L-PI-09-100 10 CFR 50.90

Prairie Island Nuclear Generating Plant Units 1 and 2 Dockets 50-282 and 50-306 License Nos. DPR-42 and DPR-60

Supplement to License Amendment Request (LAR) to Apply Surveillance Requirement (SR) 3.0.2 Interval Extension to SR 3.8.1.8 (TAC Nos. ME0811 and ME0812)

Enclosure 1

NF-40325-1, Interlock Logic Diagram Diesel Generator System Unit 1 & 2

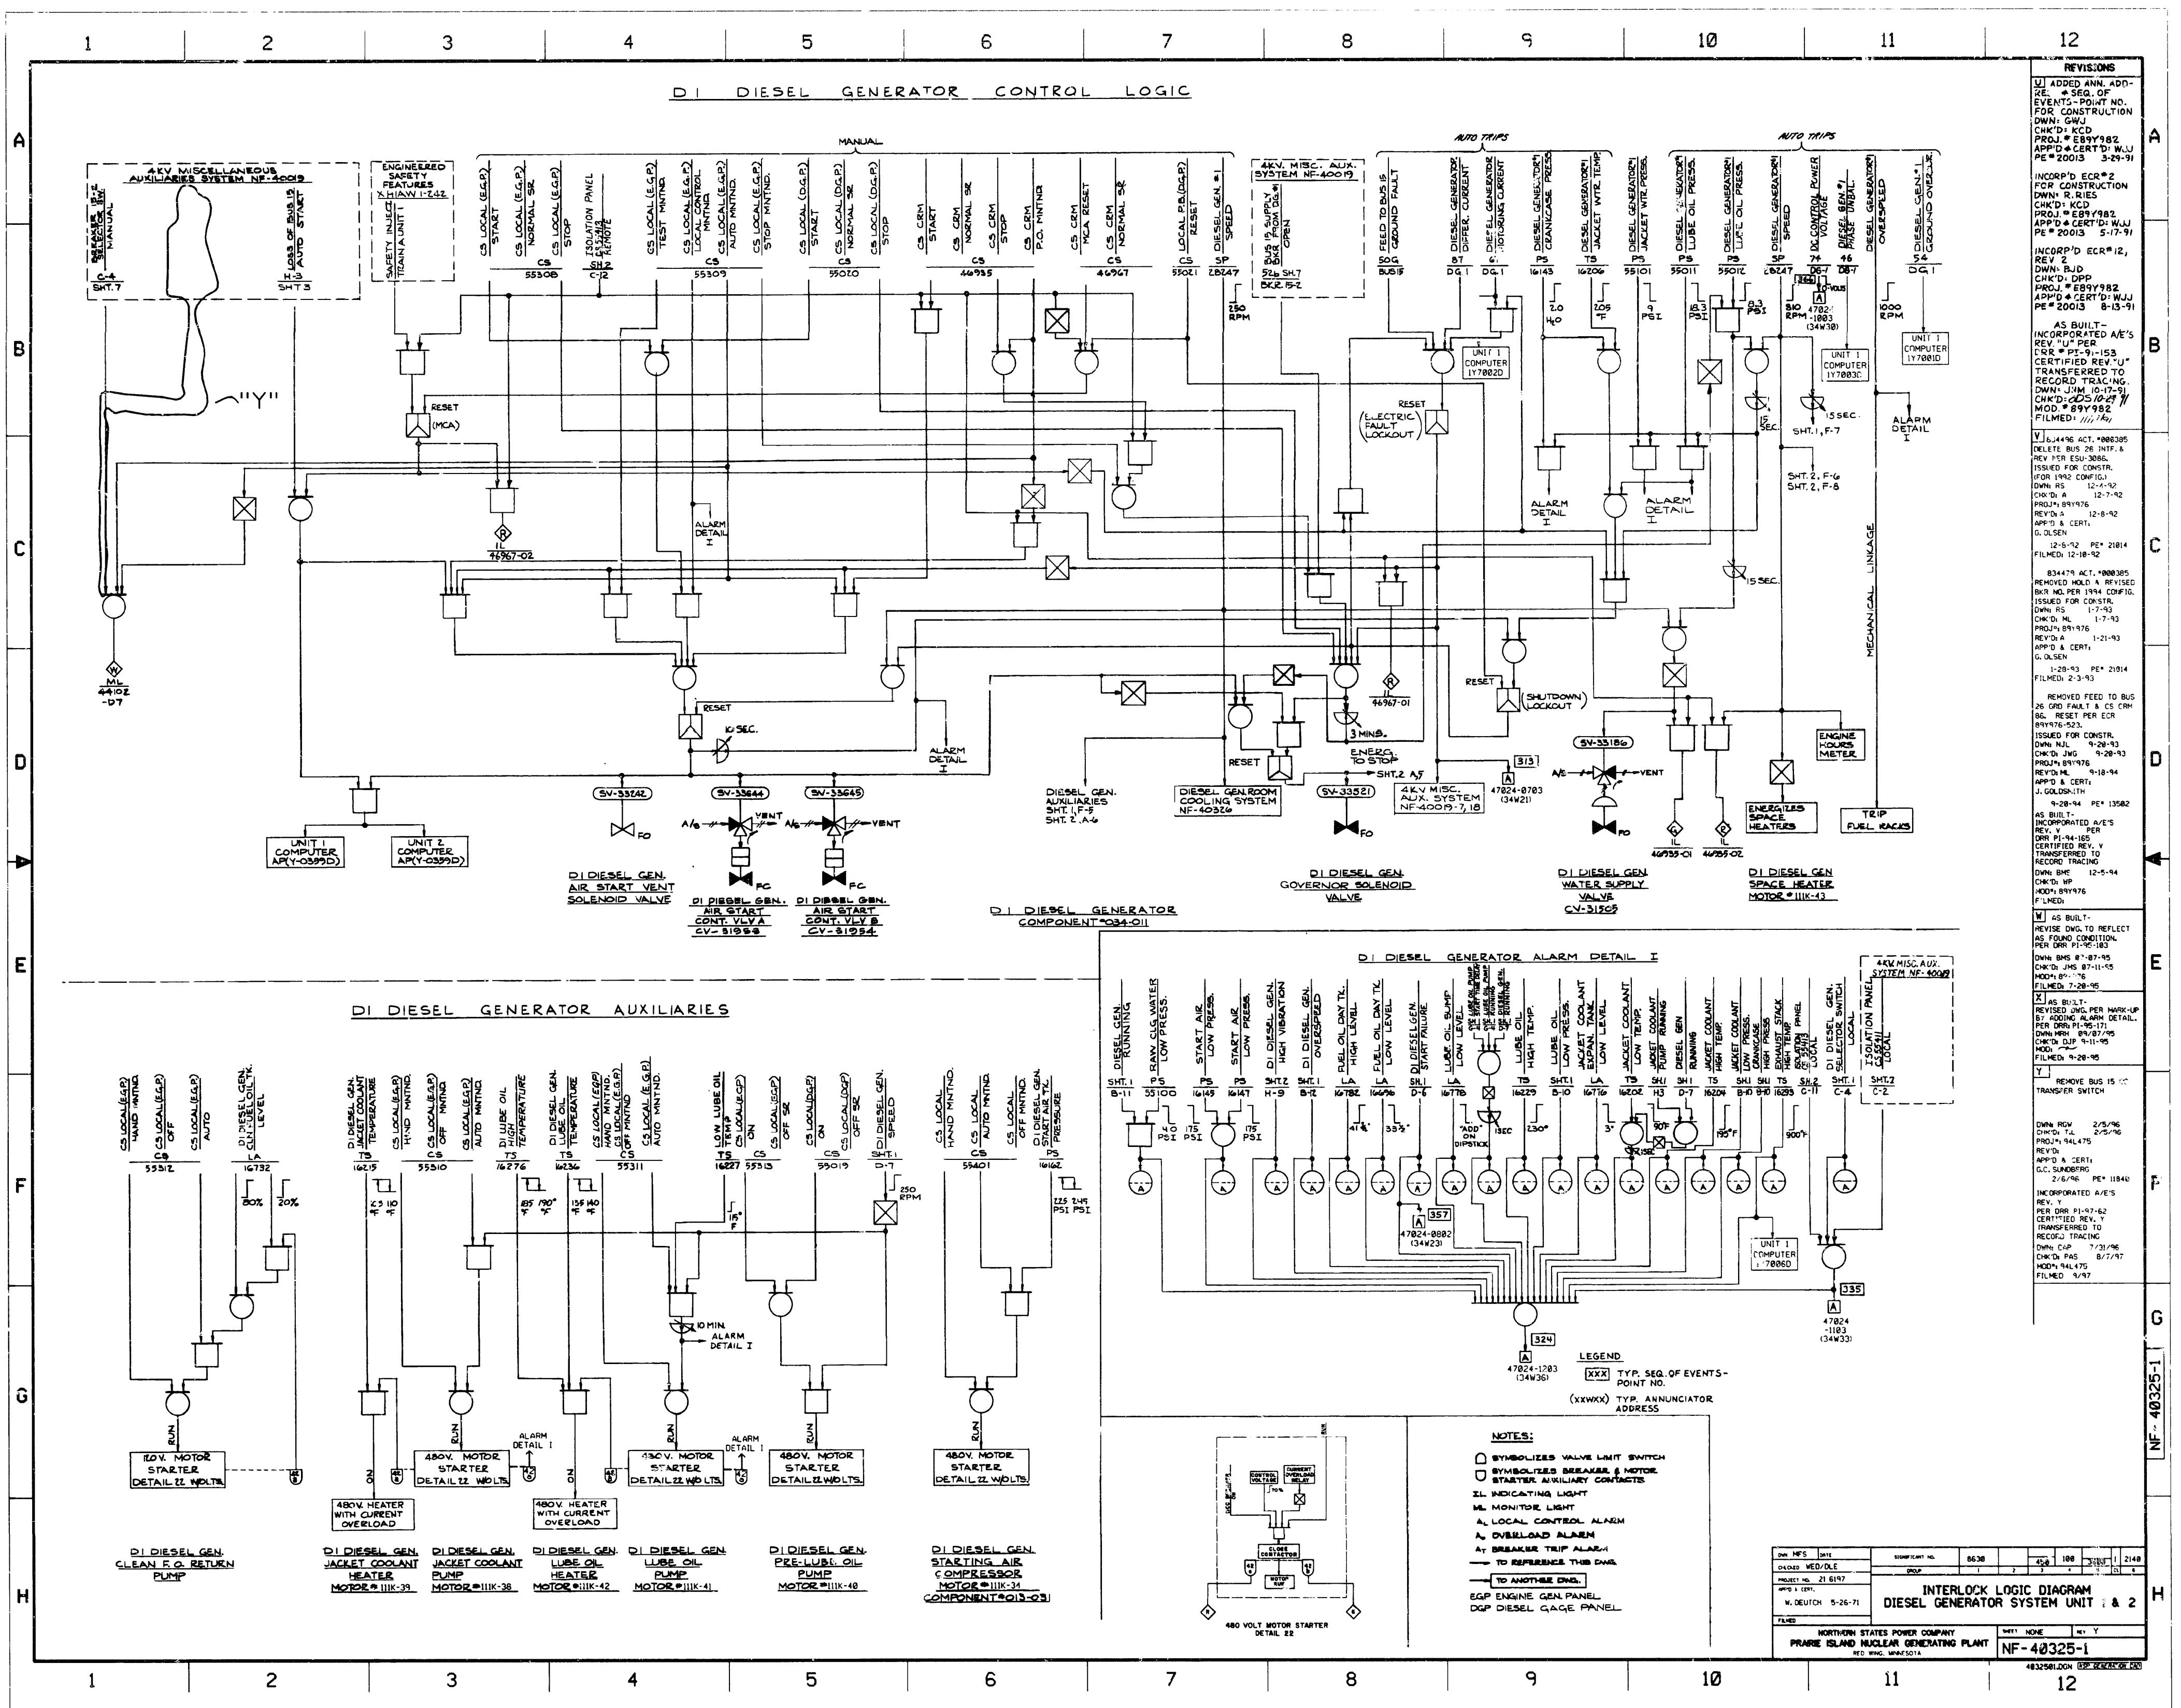
NRC RAI 2.) Submit for the NRC staff's review, the applicable portions of representative procedures for performing SR 3.8.1.8 and relevant representative drawings showing the relays that provide the function to bypass the emergency diesel generator non-critical automatic trips on an actual or simulated safety injection signal. Also, discuss whether critical trips are tested as part of SR 3.8.1.8 or some other plant procedure.

The procedures for performing SR 3.8.1.8 are SP-1150 (D1), SP-1306 (D2), SP-2150 (D5), and SP-2306 (D6). SP-1150 and SP-2306 are attached for review as a representative procedure for each unit. Additionally, as requested, representative logic drawings for each unit showing how the MCA (Maximum Credible Accident) and SIMR (Safety Injection Master Relay) relays operate, and bypass the non-critical trips during a safety injection signal, are attached.

The critical trips (engine overspeed, generator differential current, and ground fault (Unit 1 only)) are not tested as a part of surveillance procedures SP-1150, SP-1306, SP-2150, and SP-2306.
